An Bord Pleanála
 64 Marlborough Street
 Dublin 1
 D01 V902

Construction of the Boyne Greenway Drogheda to Mornington, Co. Meath & Co. Louth (APB-307652-20)

(Extract of map taken from SI 626/2011 showing SPA starts at centre of road)

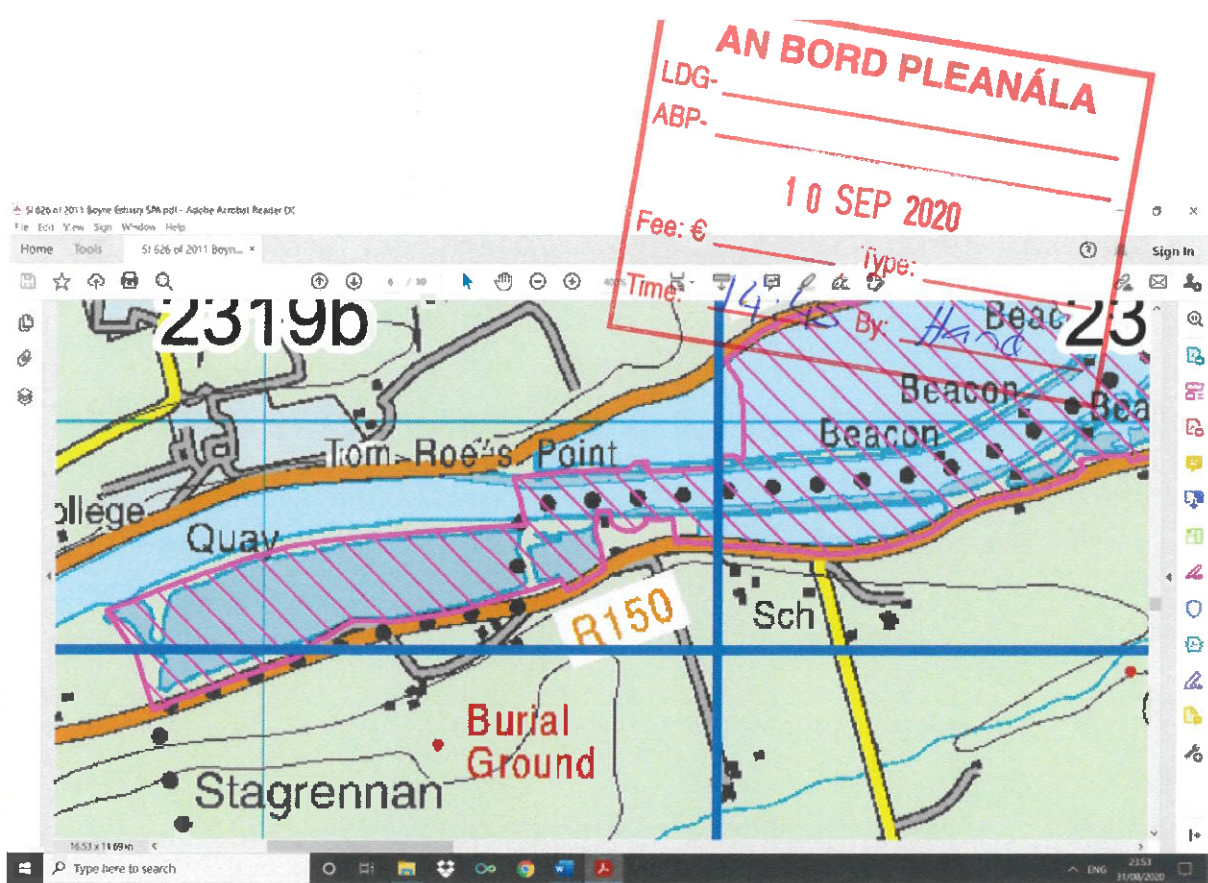
- e) The outline of the SPA, as contained in Statutory Instrument No. 626 of 2011 (See Enclosure 1 attached, available from www.npws.ie), runs from the centre of the road R150 at the Meath/Louth county boundary at Stagrennan northwards across the River Boyne Estuary and means any construction on the northern edge of the R150 road (apart from private property) encroaches into the SPA and/or the SAC.
